UNITED STATES PATENT AND TRADEMARK OFFICE

APPLICATION NO.	FILING DATE	FIRST NAMED INVENTOR	ATTORNEY DOCKET NO.	CONFIRMATION NO.
10/615,614	07/08/2003	Michael A. Funari	644-031014	8274

Office Action Summary	Application No. 10/615,614	Applicant(s) FUNARI ET AL. eb	
	Examiner J. Casimer Jacyna	Art Unit 3751

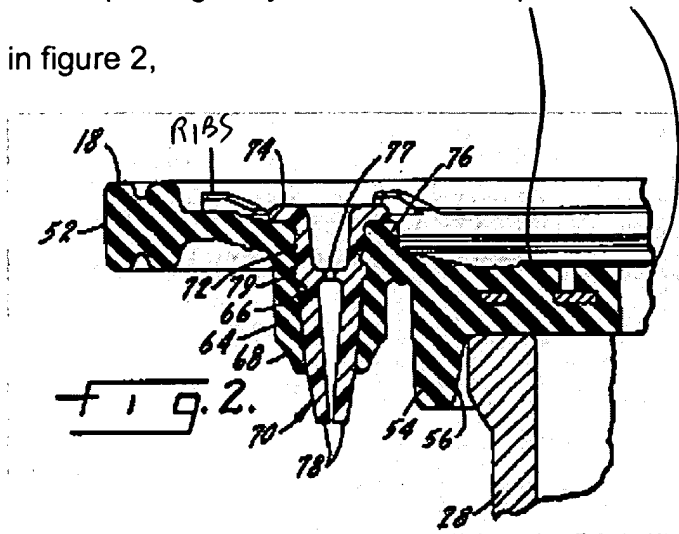
5. Claims 7, 9 and 11 are rejected under 35 U.S.C. 102(b) as being anticipated by Wilson (5,967,182). Wilson/182 discloses a flexible two sided diaphragm including a center passageway 76, an annular protrusion adjacent 76 as shown in figure 2,

protruding ribs 80 on the same diaphragm side as the annular protrusion as claimed with a gap or recess between the ribs and the protrusion, with the side having the ribs and protrusion is shown as concave in figure 2 as claimed, and an orifice (see claim 9) 84, 86 that is capable of receiving a filter as claimed.
